### PRELIMINARY FINDINGS AND DETERMINATIONS

#### Type II Zoning Permit ABRA Auto Body & Glass Special Review #714

**TITLE:** ABRA Auto Body & Glass, Major Modification to Special Review #714

**APPLICATION TYPE:** Major Amendment to Special Review #714

*Eisenhower Blvd (north) elevation. The existing building to the left is greyed out.*

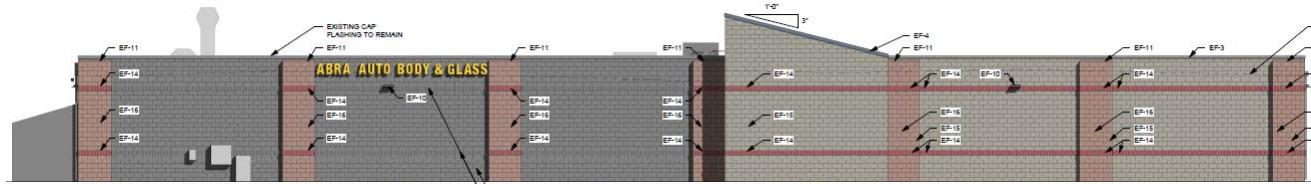
The building expansion will complement the existing structure in height, design, materials and colors. Staff had some concerns that the existing building had a plain appearance along Eisenhower Blvd, which is contrary to the goals of city plans and codes for major streets. In response, the applicant added pilasters to the building addition and also designed retrofitted pilasters onto the existing structure's Eisenhower façade.

The existing Eisenhower façade is 94 ft and the addition will add another 84 ft. Per the commercial architectural standards of the zoning code, facades cannot extend more than 100 ft without including a change in plane. Staff and the applicant together worked on developing a solution to this matter. Typically the change in plane is created by stepping back portions of the building. The building addition could not be stepped inward without impacting needed interior floorspace or parking to the south of the addition. Instead, a 23.7 ft portion of the Eisenhower façade was bumped out by 4 ft to break the plane. This bumpout encroaches into the 25 ft minimum Eisenhower setback, and as part of the special review process, approval of this setback encroachment is sought. Staff is supportive of the encroachment, as the remaining setback from the street is still significant (21 ft) and the “big box” appearance of the structure that would otherwise

result has been avoided, while meeting the interior space needs of the applicant. In addition, the roofline of this 23.7 ft stretch of wall is bumped up into a type of angular parapet, which functions both to break the otherwise monotonous roofline of the 18 ft tall building and to screen rooftop equipment.

6. The overhead bay door on the west elevation shall be of a color to blend with the adjacent wall. Revised elevations are to be submitted to and accepted by the city prior to Current Planning approval of the special review/site development plan.

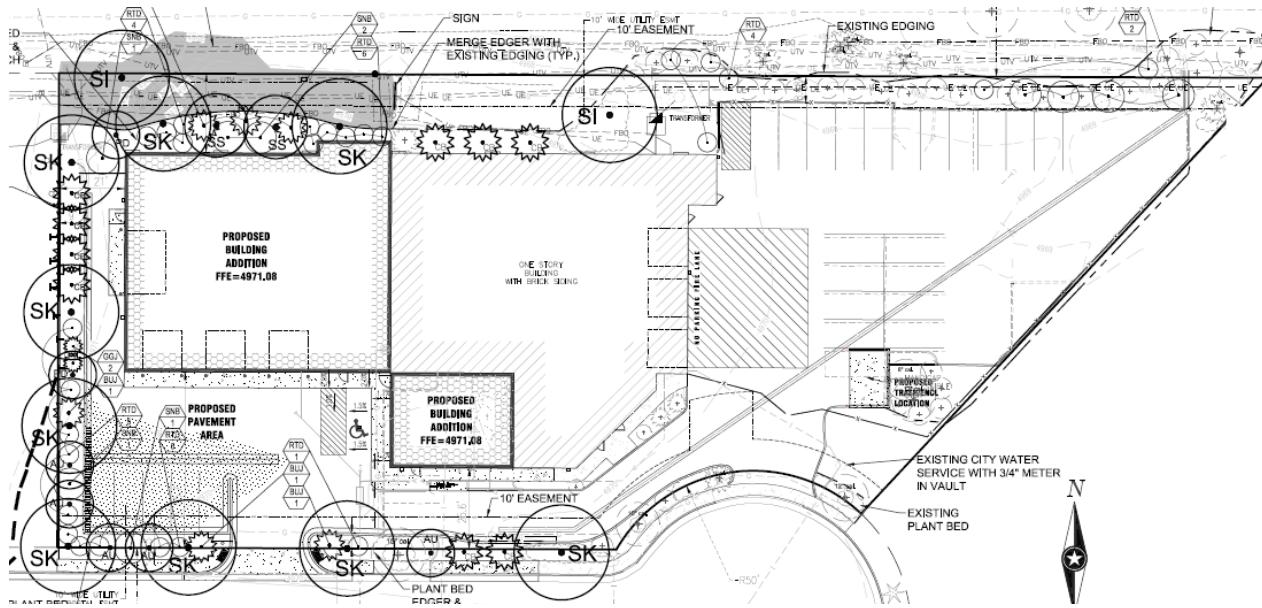
The site plan includes modifications to the larger parking lot to the east of the building, along with the relocation of the smaller parking lot from south of the existing building to south of the shop addition. There is currently one driveway access into the property located off of Topaz Dr immediately south of the existing building, with a driveway then extending east to the larger parking lot. With the relocation of the customer parking lot farther to the west, the driveway access is also being moved farther west, with a drive extending to the east parking lot. In addition, a new driveway will extend along the west side of the building addition to allow for access to the overhead bay door along that wall.

Configuration and placement of vehicular and pedestrian access and circulation is compliant with City standards. Vehicle drive aisles within the east parking area are unchanged. The customer parking area is moving from south of the existing building to south of the addition, and the curb cut off of Topaz Dr is moving farther west to accommodate the relocated parking area. The drive aisle from the curb cut to the east parking area will remain. Both Transportation and Fire Department staff have reviewed the special review plans and have indicated compliance with the City's Adequate Communities Facilities Ordinance.

The handicap space will be relocated from the east parking lot to the south parking lot. The relocation of the handicap space is an improvement, as per code, handicap spaces are to be located closest to the accessible entrance. The new location will situate it as such, but the existing location situates the handicap space relatively far from the entrance. The trash enclosure will be relocated from the north end of the east parking lot, near the Eisenhower lot line, to the south end where the handicap space is now located. New parking spaces will be striped where the trash enclosure now sits and a couple new spaces will be striped where the wall enclosing the serviced vehicle storage area is now located. The east lot parking configuration will otherwise remain unchanged.

## Fence

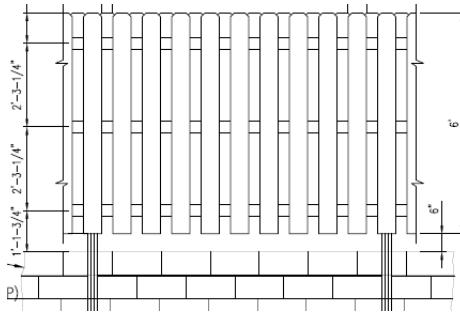
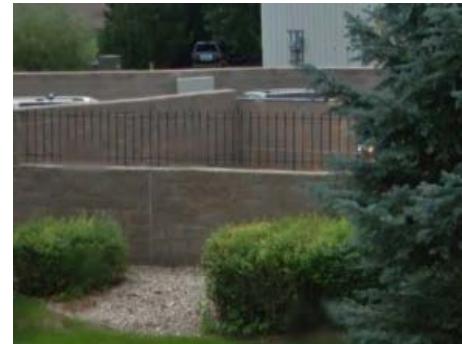
The Eisenhower frontage of the east parking lot is currently lined by a wrought iron fence on top of textured beige CMU that match those of the building. A full wall of the same CMU encloses the serviced vehicle storage area in the northeast portion of the parking lot. This wall runs along approximately half of the east property line. With the building addition, the applicant proposes to enclose the entire east parking lot. The wall/fence along Eisenhower will remain, with the wall enclosing the serviced vehicle area removed.

As proposed, a low concrete block wall with a cedar fence on top would be installed along the east property line and along the south side of the east parking lot, with a steel frame and cedar swing gate at the parking lot entrance. At the neighborhood meeting, a strong preference for a solid CMU or other stone material, or combination stone/wrought iron wall/fence, was expressed by all in attendance. A condition of approval addressing this has been included in these findings by Current Planning.

Attendees did not support the proposed new fence for the east and south side of the east parking lot, which includes a cedar board fence over a stone wall. Installation of a fence entirely of stone material was preferred, as it would be in keeping with the style of fence on other properties in the immediate vicinity, or a stone fence with a small wrought iron fence on top, which would be in keeping with the fence along the Eisenhower frontage of the property. A condition concerning the fence material has been added to these Preliminary Findings to address this concern.

5. A revised enclosure for the east parking lot that matches the existing concrete masonry unit wall/wrought iron fence on the Eisenhower Blvd frontage, or consists entirely of masonry that complements the concrete masonry unit/wrought iron fence, is to be submitted to and accepted by the city prior to Current Planning approval of the special review/site development plan.
